Re: *San Joaquin River Flow and Salinity Basin Plan Amendment Proceedings*

Power Operation Impact Analysis Associated with SWRCB Staff Vernalis Flow Requirements¹

Subject: Merced River Hydroelectric Project, FERC Project 2179-042
Model Run Results

Figure 1 – New Melones Generation (GWH/yr)

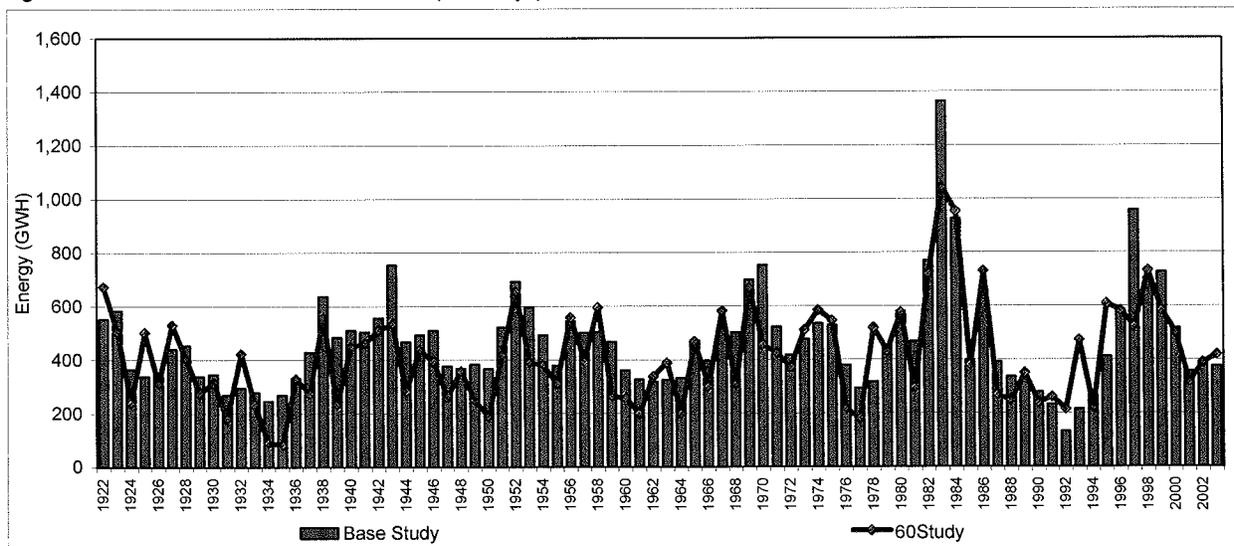
Figure 1 illustrates the annual energy production (at plant) for the New Melones generators for the modeled 1922-2003 hydrologic period. Shown are the results for both the baseline study (Base Study) and the test study (60Study). Each year average annual generation differs between the two operations, with the average annual energy decreasing by about 55 GWH/yr, about 12 percent, due to the increased flow requirements.

Figure 2a – New Melones Generation (GWH) Wet and Above Normal Years

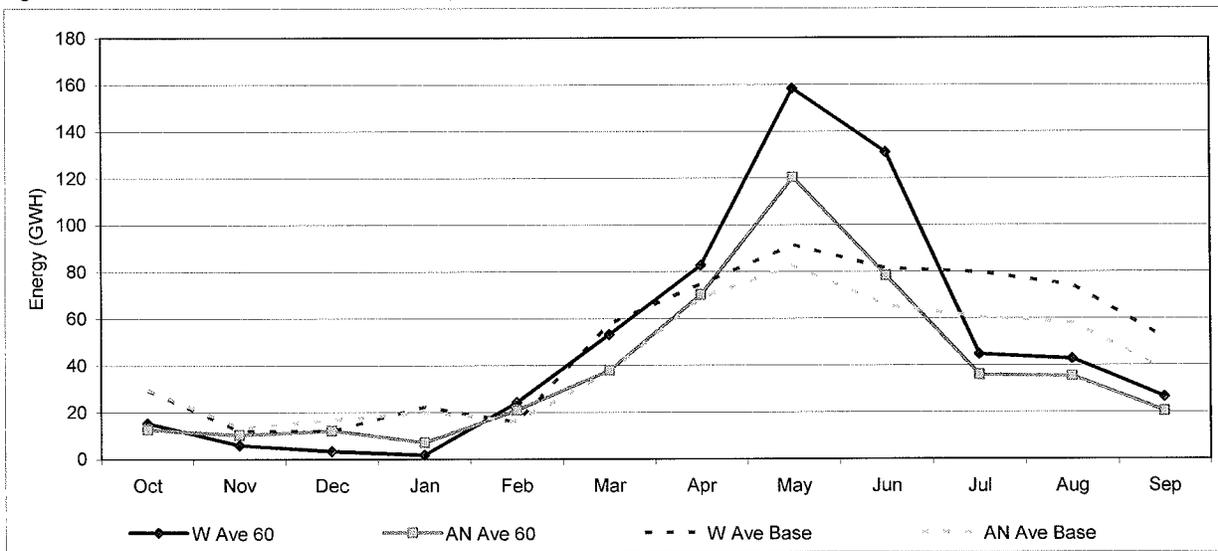
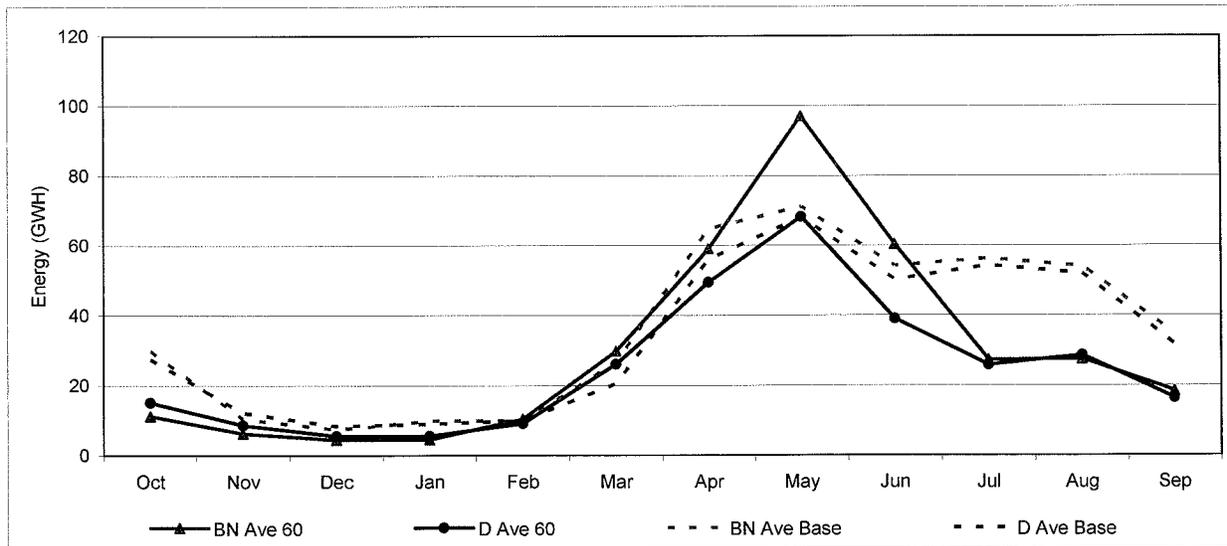
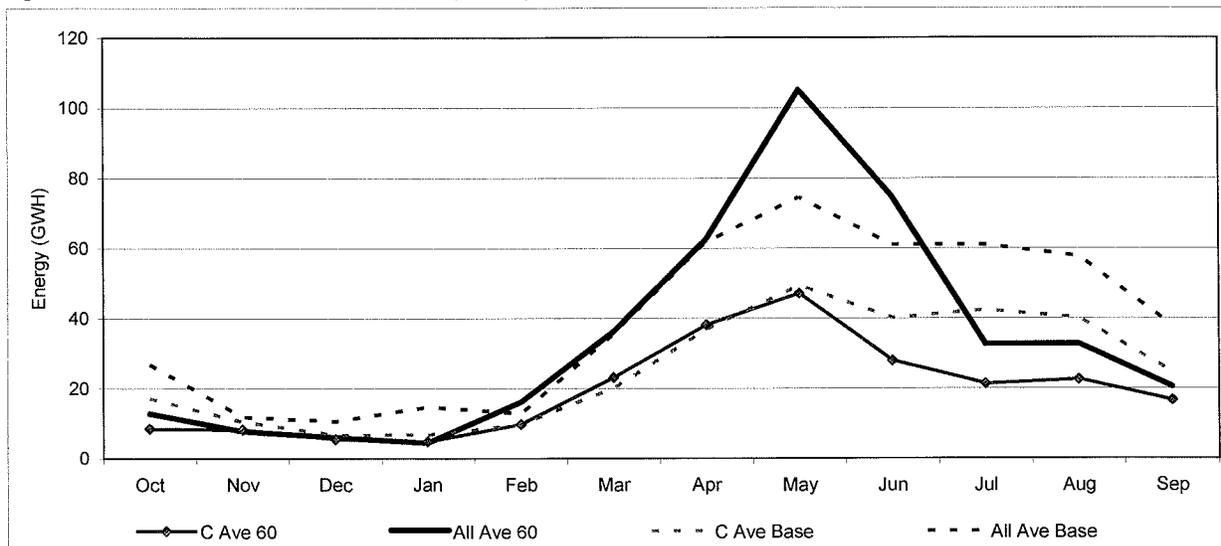
The results show that average annual generation decreases with the increased flow requirements due to an overall reduction in head (lower reservoir stage) throughout the study period. There is also a shifting of generation from the summer into the May and June period (except in dry and critical years) which follows the increase of the flow which mimics the unimpaired runoff shape during that period. Generation is reduced during the summer due to the reduction in canal diversions which is associated with the loss in water supply which is now used for river releases earlier in the year. Results indicate there will be periods of no, or foregone generation (bypass of generators) under conditions when the reservoir is below minimum power pool or when releases exceed plant capability.

Figure 3 – Don Pedro Generation (GWH/yr)

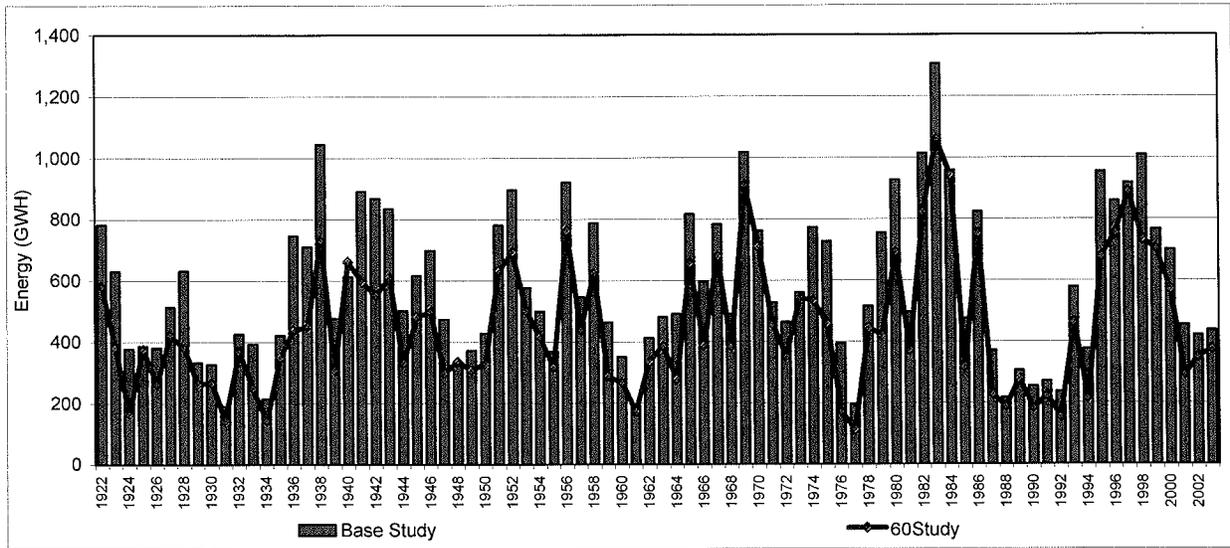
Figure 3 illustrates the annual energy production (at plant) for the Don Pedro generators for the modeled 1922-2003 hydrologic period. Shown are the results for both the baseline study (Base Study) and the test study (60Study). Each year average annual generation differs between the two operations, with the average annual energy decreasing by about 135 GWH/yr, about 23 percent, due to the increased flow requirements.

Figure 4a – Don Pedro Generation (GWH) Wet and Above Normal Years

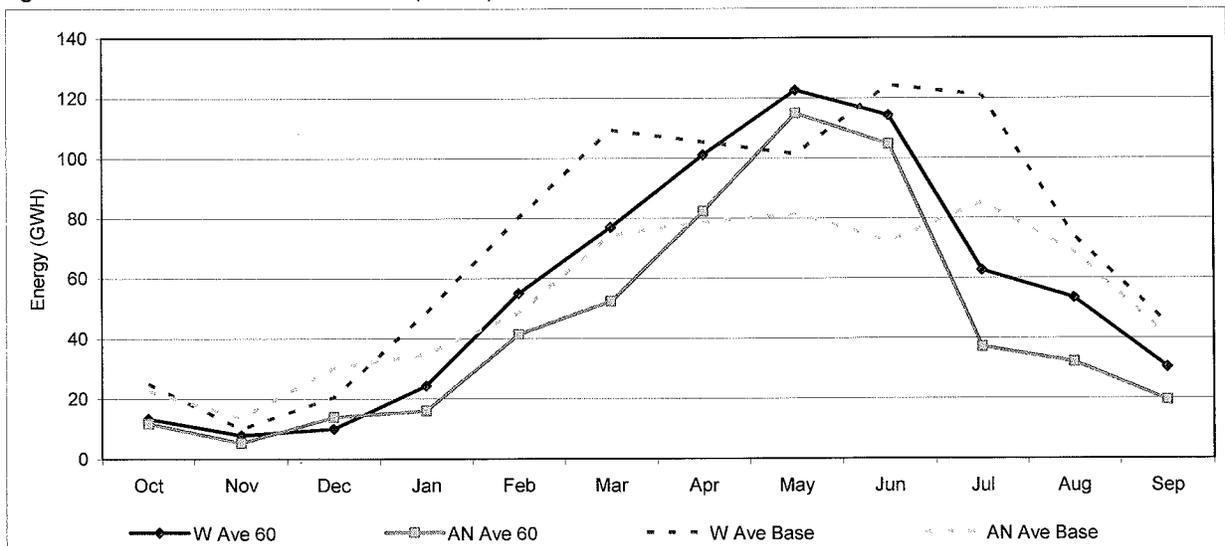
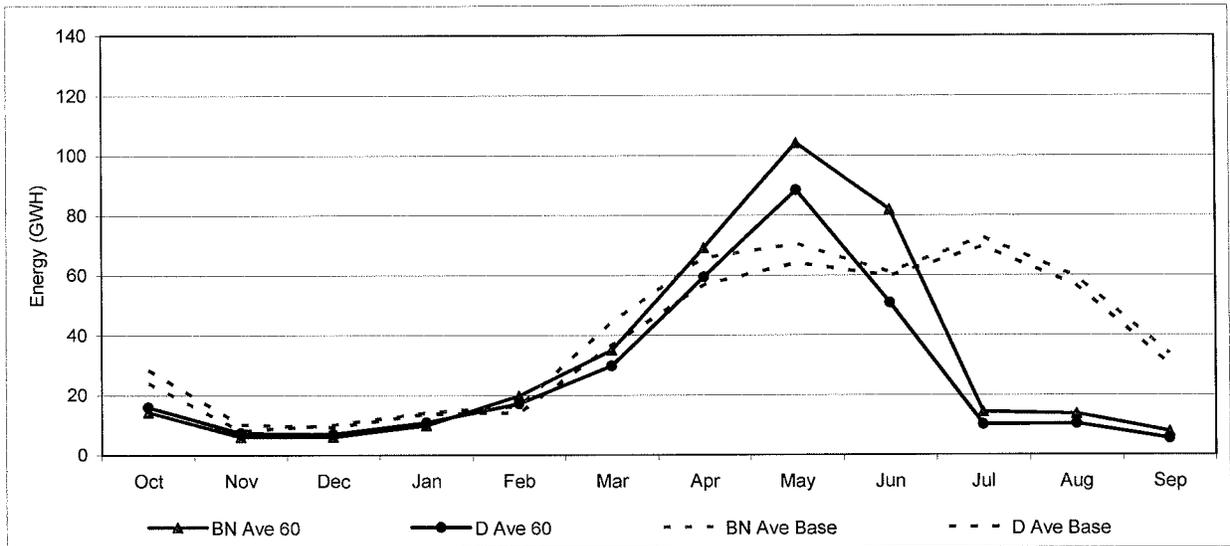
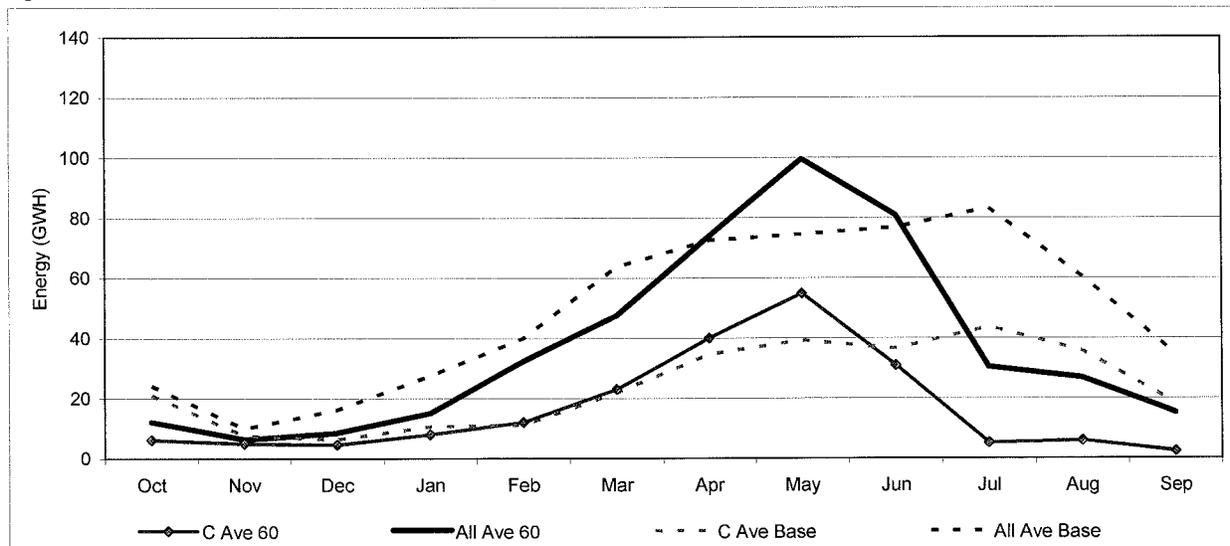
Similar in results for the New Melones Project, the average annual generation of the Don Pedro Project decreases with the increased flow requirements due to an overall reduction in head (lower reservoir stage) throughout the study period. A shifting of generation from the summer into the May and June period (except in dry and critical years) occurs which follows the increase of the flow that mimics the unimpaired runoff shape during that period. Early winter generation may be reduced in wetter years due to fewer releases for flood control operations. Generation is reduced during the summer due to the reduction in canal diversions which are associated with the loss in water supply which is now used for river releases earlier in the year. Results indicate there could be periods of foregone generation (bypass of generators) under conditions when the releases exceed plant capability.

Figure 6 – Comparison of Merced River Project Seasonal Generation

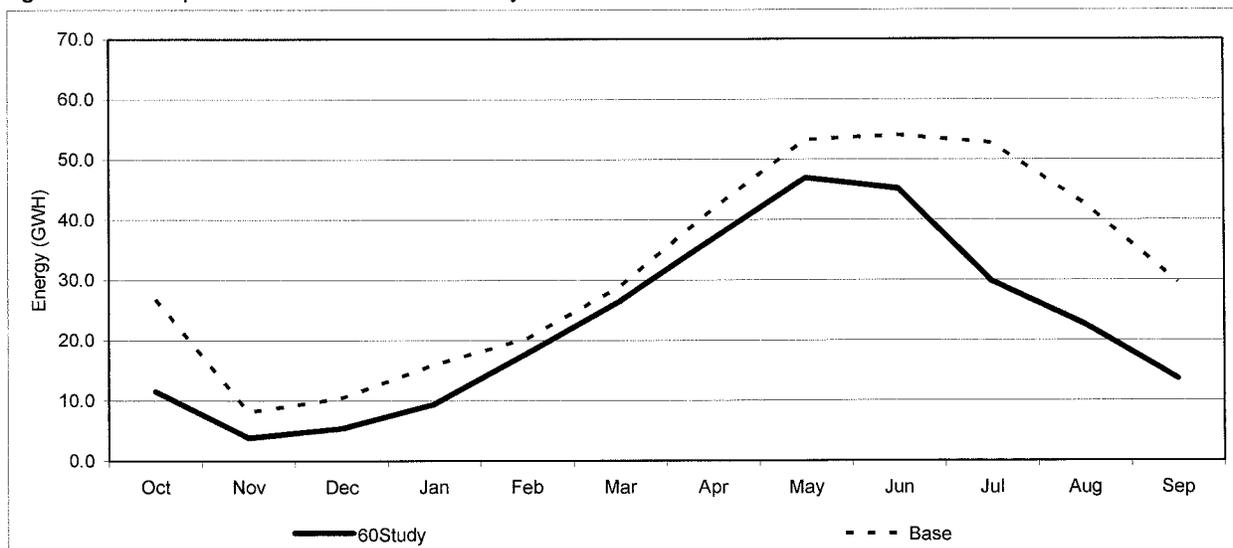
Table 3 illustrates the energy production (at plant) for the Merced River Project under the baseline (Case 1 / Base) and test study (NMFS121710A / 60Study) condition. Annual generation by year type and changes from the baseline are shown. Figure 6 illustrates the seasonal shift of annual average generation.
